P 37190

SEWAGE DISPOSAL SYSTEM

HOWARD COUNTY HEALTH DEPARTMENT

RE: Building Permit No. 25513
Proposed Addition
7081 Pindell School Road

A Repair
P 37190

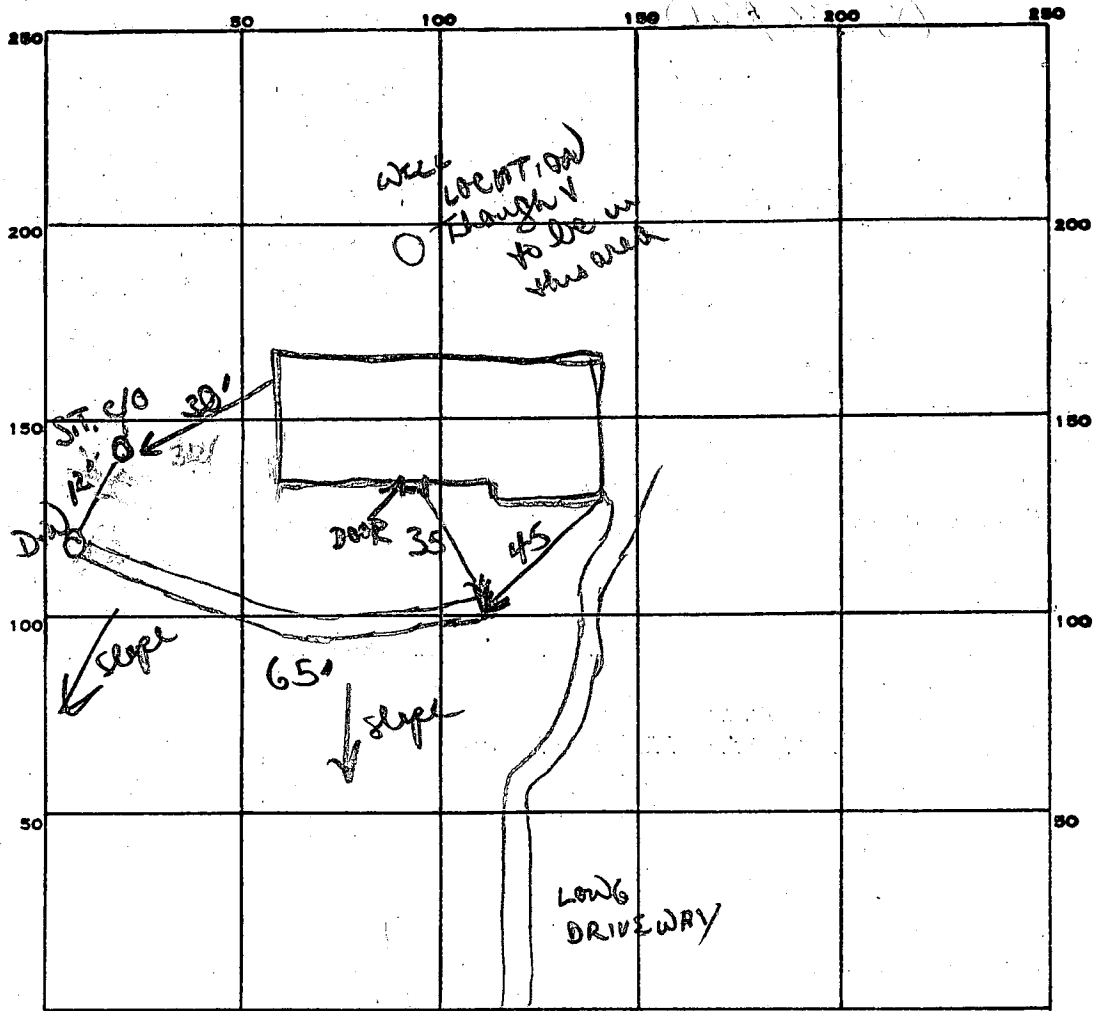
REPAIR - CALL FOR INSPECTION WHEN GROUND IS OPENED UP SO SANITARIAN CAN RECOMMEND

Soils predominately sandy/mica loam
OK to top into existing d.w. & add on new trench

REMARKS 5/29/86
OK to start system at 2' deep (good soils)
OK to add stone pipe paper to trench & cover
OK to cover all work

30648

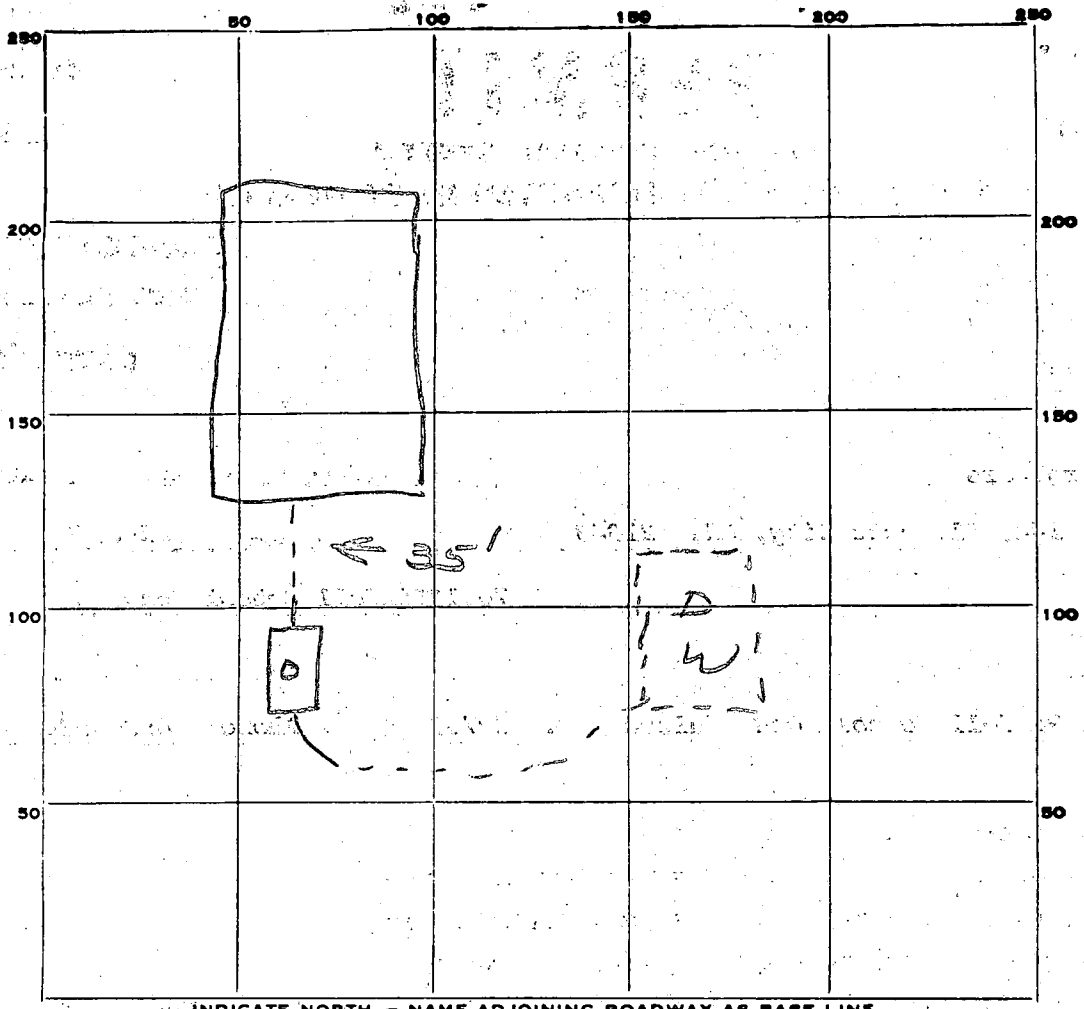
REPLACE METAL TANK THAT HAS COLLAPSED WITH 1000 GALLON CONCRETE TANK.

REMARKS 4/25/80 OK to cover all work. J

DETAILED DRAWING
SUBMITTED,

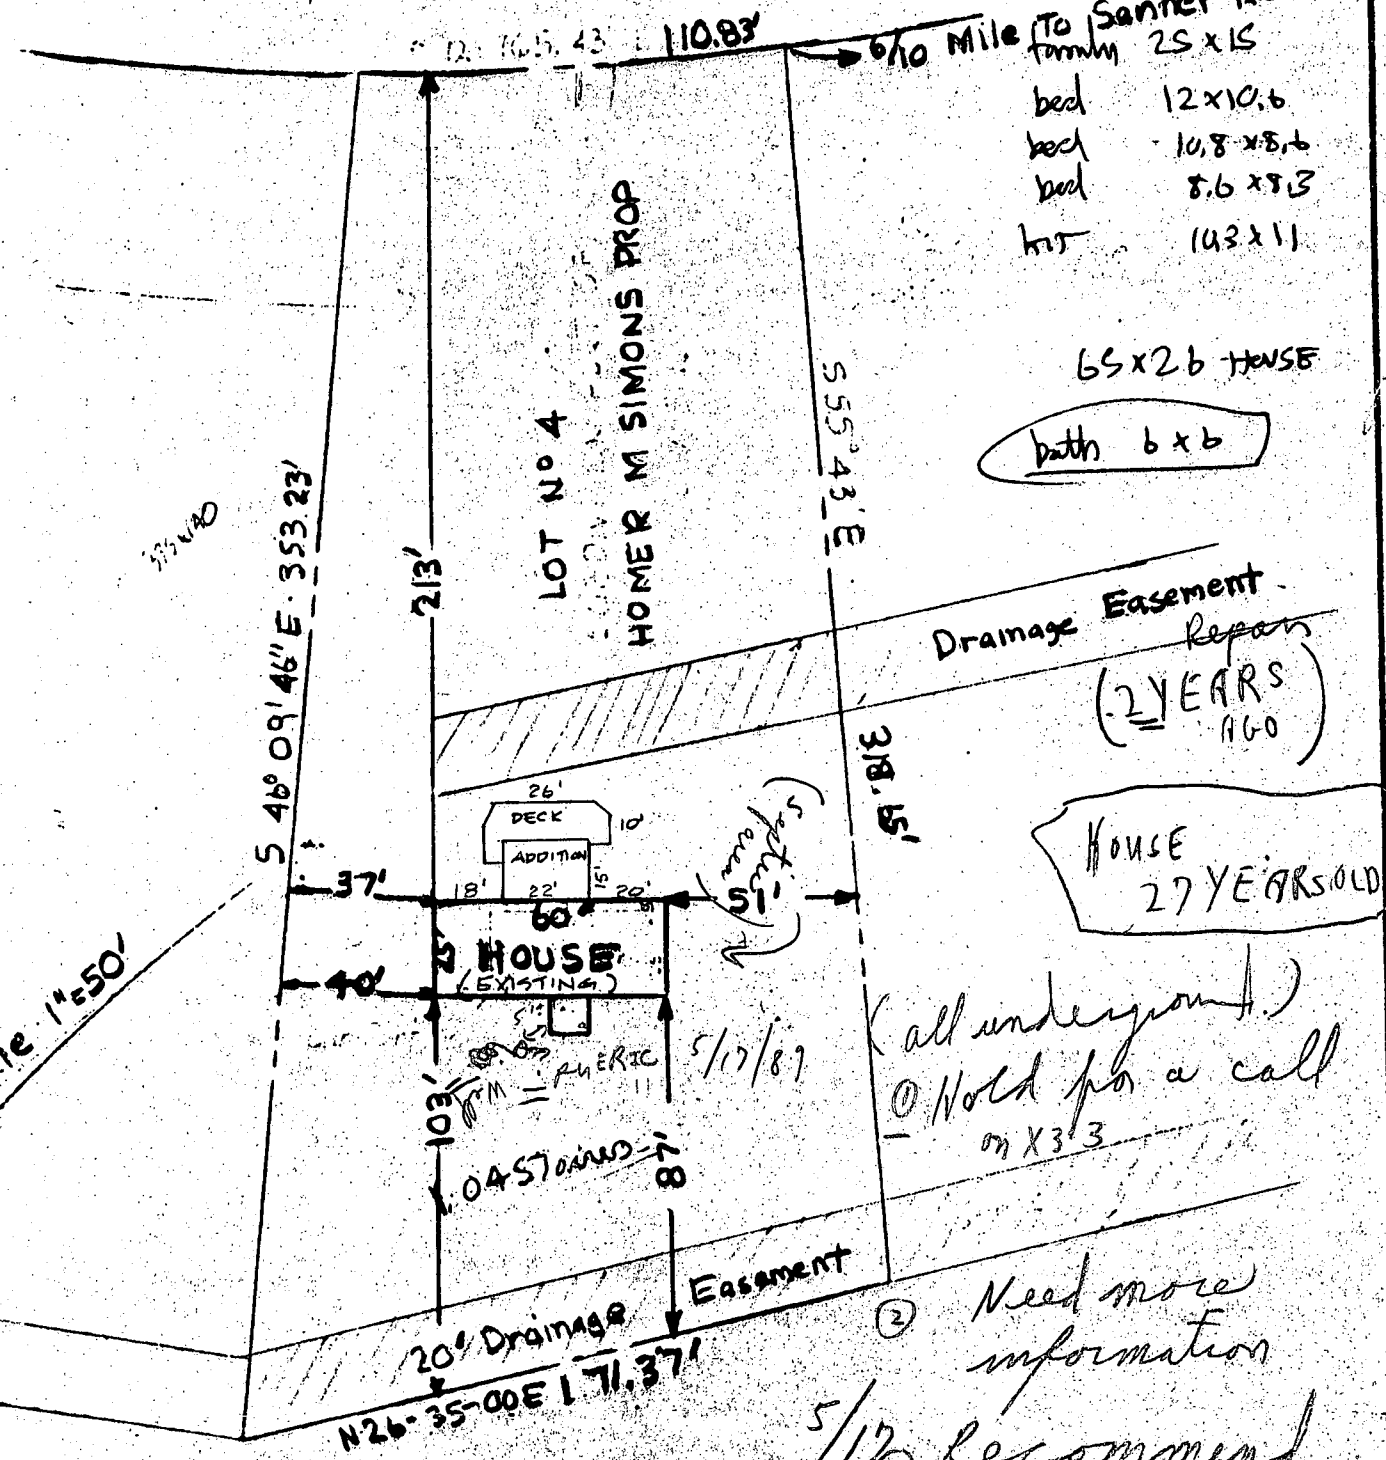
This is to advise that this office cannot recommend approval of the above referenced building permit application at this time because of concern about potential impact on your septic system.

Please forward a revised copy of your building permit drawing showing the relationship of the proposed addition relative to the septic system. The required separation from the house to the sewage disposal trench is 20 feet. Minor variances to that distance could be considered for the deck depending upon its construction.

(all underground)
① Hold for a call on X33

② Need more information
5/17/89
③ recommend repair C.B.D.

OK
5/30/89 CW
